**FINAL
ENVIRONMENTAL IMPACT REPORT**

**DEL PASO REGIONAL PARK MASTER PLAN
IMPLEMENTATION PROGRAM**

**SCH# 84091704
JANUARY 1985**

SUBJECT: Final EIR for the Del Paso Regional Park Master Plan Implementation Program

FIGURE 2.

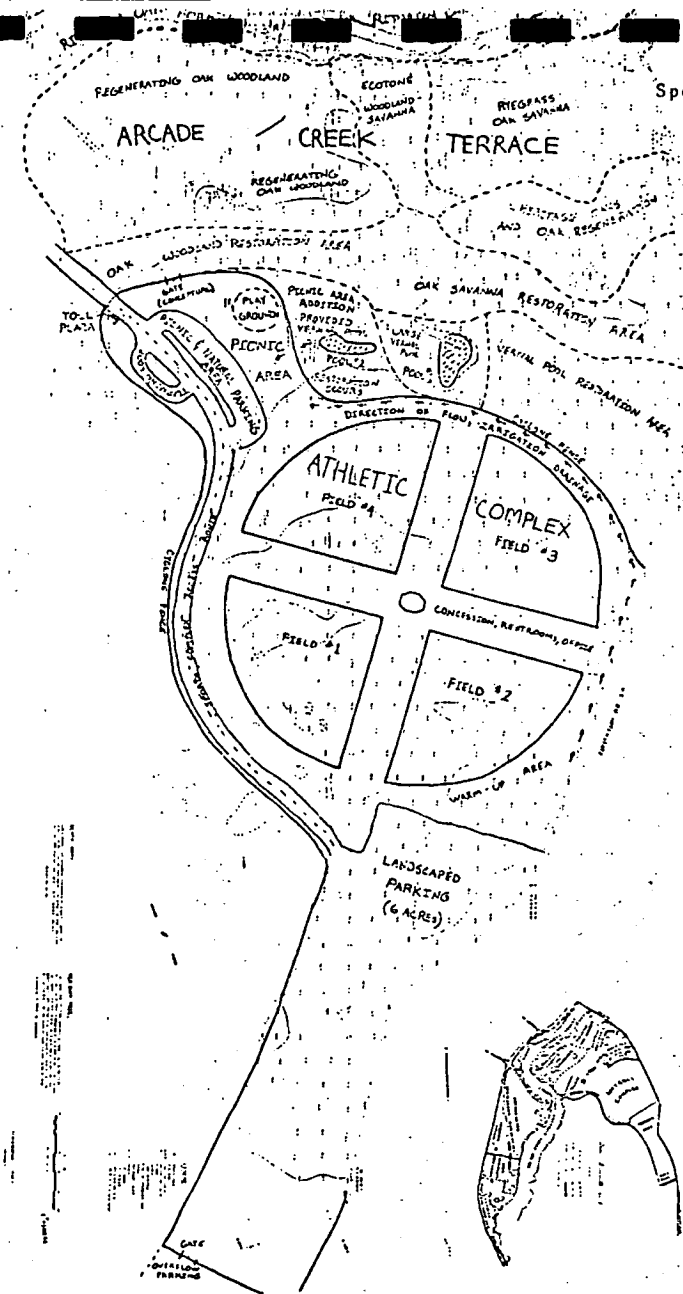
Access Route: The access route for the sports complex 2A plan would leave Longview Drive opposite Industry Drive, traverse the uplands along the eastern margin of the Sacramento Horseman's Association, and enter the sports complex and picnic-playground area just north of the green for hole #15 in Haggin Oaks Golf Course. This access route would, thus, stay away from the Arcade Creek terrace west of Watt Ave. - an area of regenerating oak woodland and savanna and the principle botanical asset in Del Paso Park. (Figure 2, inset). (Steve Talley for ACRP)
